SERVICE BULLETIN

M-1013

1991 MODEL UPDATE

Figure 1. Wheel Bearing Sleeve

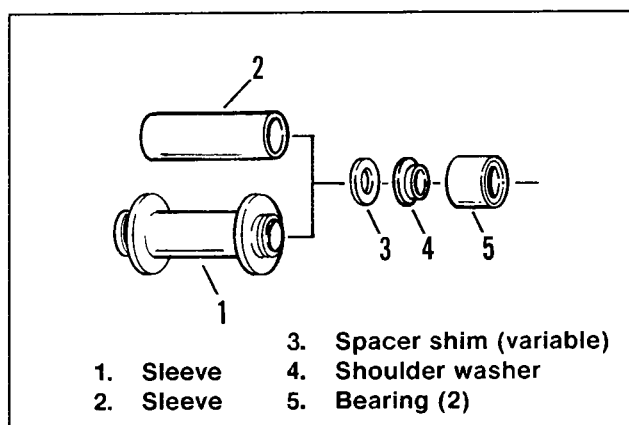
See Figure 1. As of May 15, 1991, all wheels are using FLT-style sleeves (1 and 2) and spacer shims (3) to adjust wheel end play. When installing wheel bearing components, make certain smaller O.D. side of shoulder washer (4) faces toward bearing (5). The charts which follow show the bearing sleeves and spacers used on the different sizes and styles of wheels.

Figure 2. Air/Oil Separator

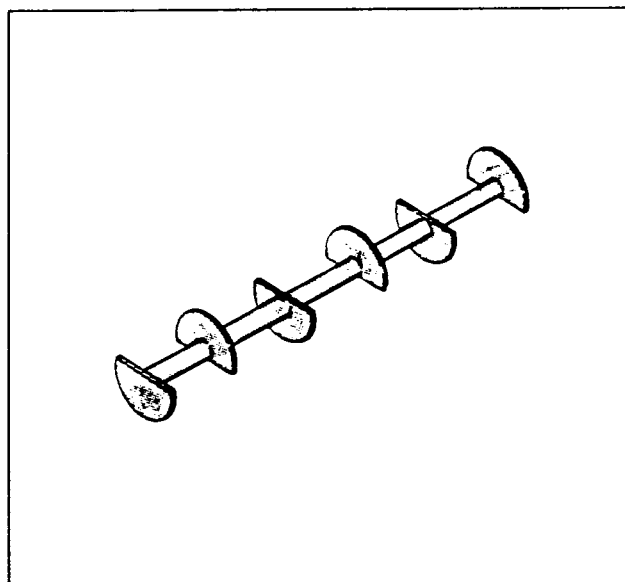
See Figure 2. As a running change in April 1991, all 1340cc engines have an air/oil separator inserted in the air duct tube on the gearcase cover. This labyrinth-style baffle aids in the separation of oil mist from the crankcase air, and further reduces the likelihood of oil carryover to the air cleaner.

You may retrofit the air/oil separator on 1984 and later 1340cc engines. The air/oil separator (H-D Part No. 25329-91) is available from Harley-Davidson on a regular parts order basis.

Figure 3. Four-Sided Fuel Inlet Valve

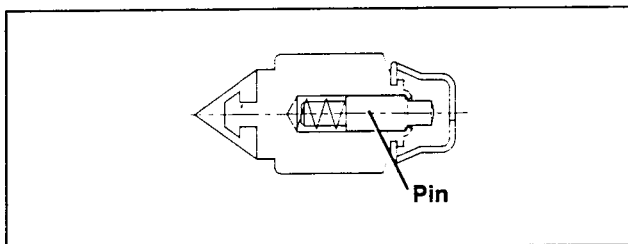
See Figure 3. As of June 1991, all 1340cc engine carburetors will have a four-sided fuel inlet valve, which improves alignment and replaces the previous three-sided style. The new inlet valve can be used on all Keihin carburetors. The four-sided inlet valve (part of Fuel Inlet Valve Kit, H-D Part No.27886-78A) is available from Harley-Davidson on a regular parts order basis.

When installing the kit, the carburetor float level must be checked according to the instructions furnished with the kit.

Figure 4. Transmission Sprocket Lockplate

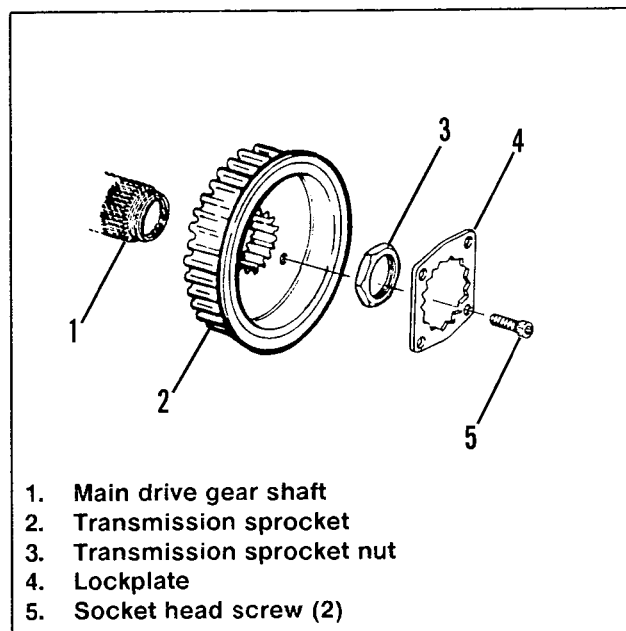
See Figure 4. Starting in mid-June (transmission No. 91168061), all 1340cc engines will be equipped with a new style lockplate (4) for the transmission sprocket (2). This change will also affect Sportster transmissions beginning with the 1992 model year. The lockplate is shaped to fit around the six corners of the transmission sprocket nut (3). The lockplate can be rotated to a number of positions, and can be positioned with either side facing the sprocket, to allow for easy alignment of two of its four drilled holes (diagonally opposite) with the sprocket's two tapped holes. The lockplate is secured to the sprocket by two hex socket head screws (5). The lockplate offers increased sprocket nut retention; it will be furnished with all new 1340cc sprocket parts orders.

When installing the transmission sprocket nut (3), apply LOCTITE® Threadlocker 262 (red) and tighten the nut to 110 - 120 ft-lbs torque. If you cannot align the lockplate (4) and sprocket screw (5) holes, the nut (3) may be additionally tightened until the screw holes line up. However, do not tighten the nut to more than 150 ft-lbs torque, and never loosen the nut, while attempting to align the screw holes. Tighten the two socket head screws (5) to 7 - 9 ft-lbs torque.

Figure 5. Transmission Support Block Dowel Pins

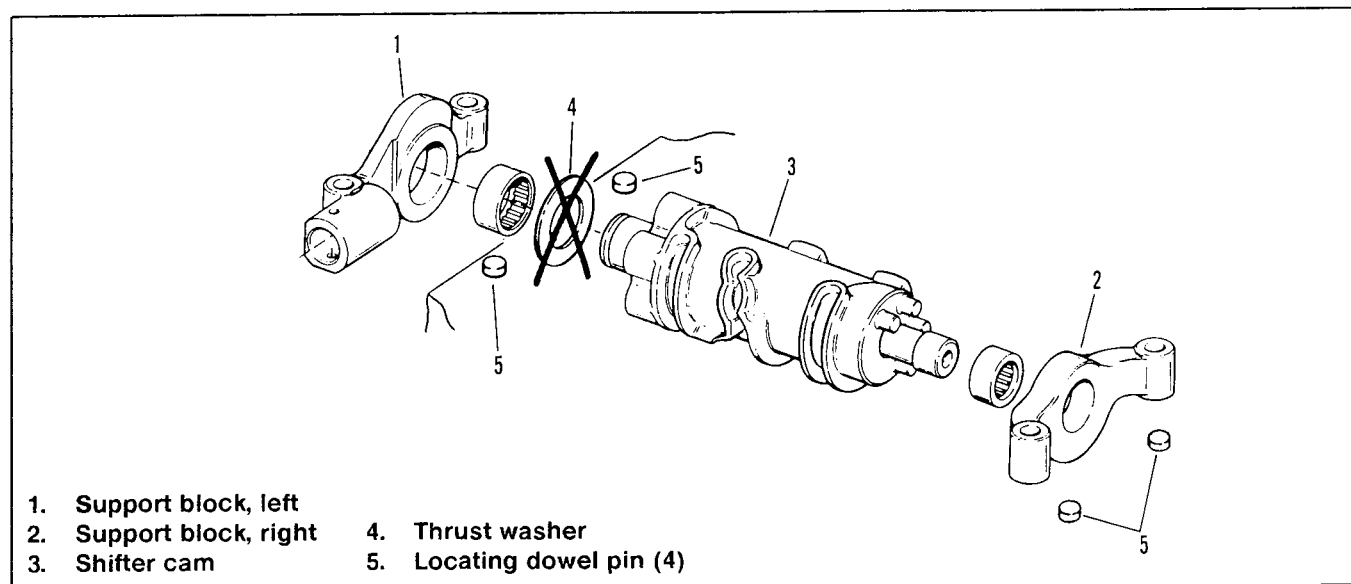
See Figure 5. As of early May (transmission No 91122004), both transmission support blocks (1 and 2) are equipped with locating dowel pins (5). With the pins at both support blocks, the distance between the support blocks can be more accurately maintained. The shifter cam (3) is now machined to allow for proper alignment with the shift forks, without the use of the thrust washer (4).

Figure 6. Alignment Tool

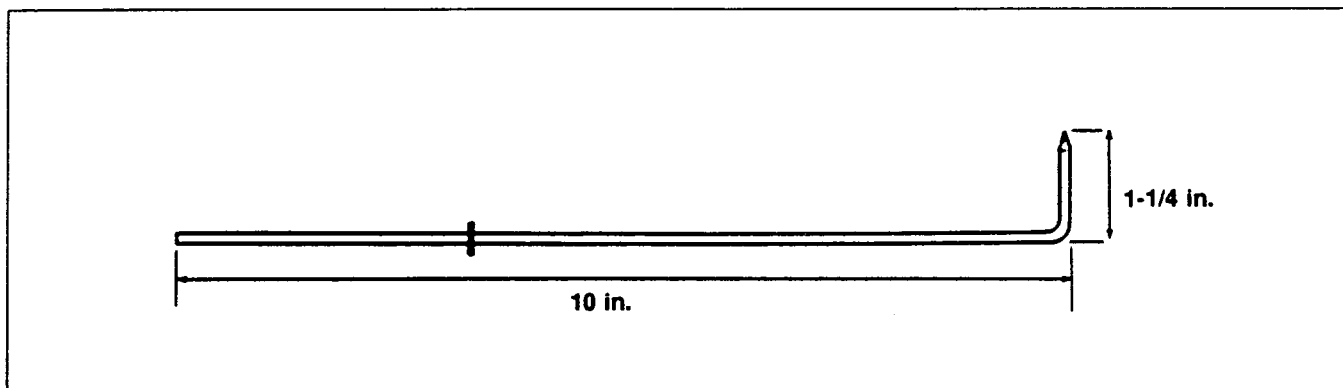
Starting in late March or early April, the rear fork on all FXR vehicles will include a hole on each side for using the same alignment tool currently used on Dynaglide and Sportster models. The holes in the rear fork permit alignment measurements to be taken at a much shorter distance providing increased accuracy. This also eliminates the long tool used to take measurements from the center of the axle to the center of the rear fork pivot. A drawing, enabling you to make the new tool, is shown in Figure 6.

Figure 7. Electrical Connection of Disable Circuit on FLHTC-Ultra

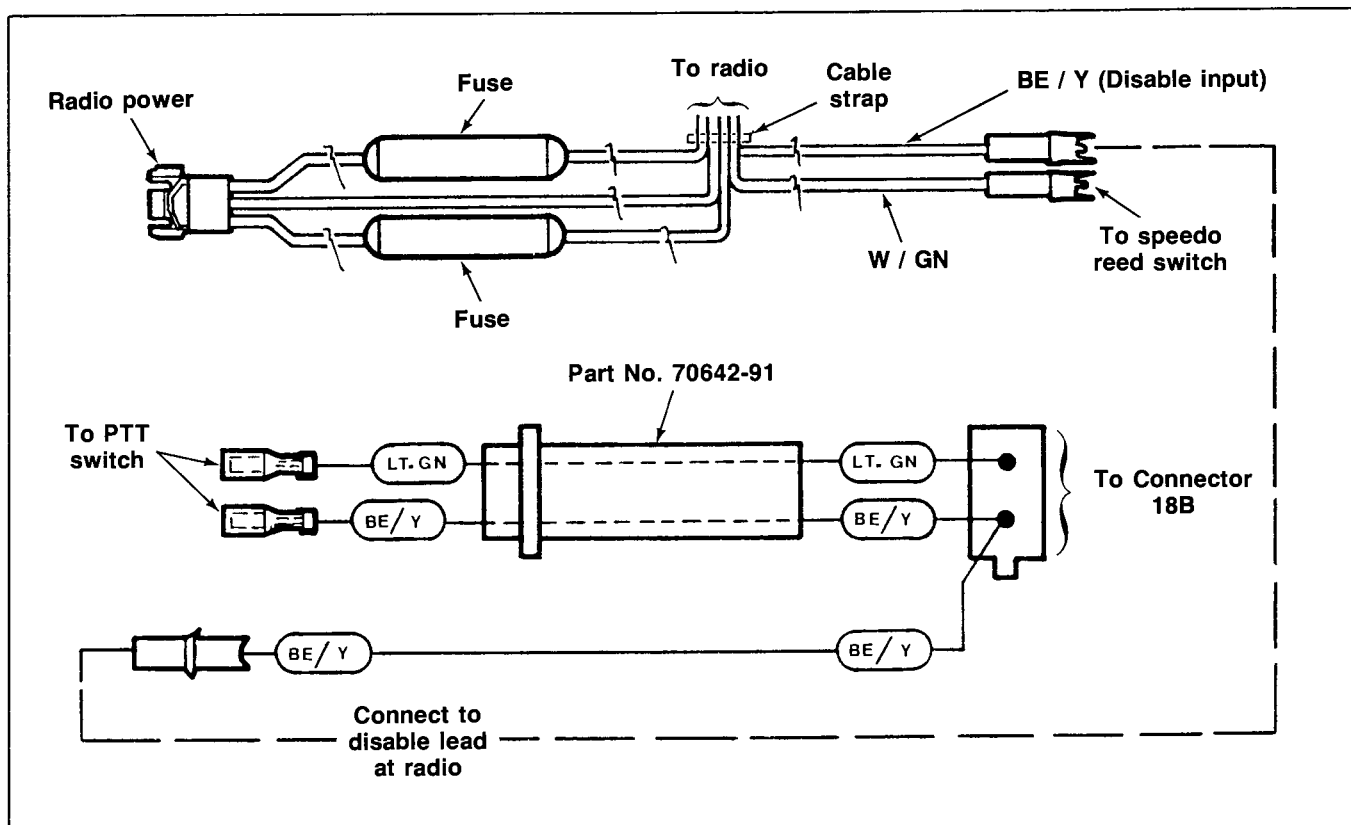
- The radio input impedance was lowered on the mute lead (in the 3-pin DIN cable) to prevent audio muting should the DIN connector become water-contaminated.
- See Figures 7 and 8 (on page 4 of 4). A circuit that disables the radio amplifier during CB transmission has been added. Disabling the amplifier eliminates the squealing noise at the fairing speakers, which is caused by feedback. The amplifier disabling circuit may be installed on any 1991 FLTC / FLHTC Ultra model.
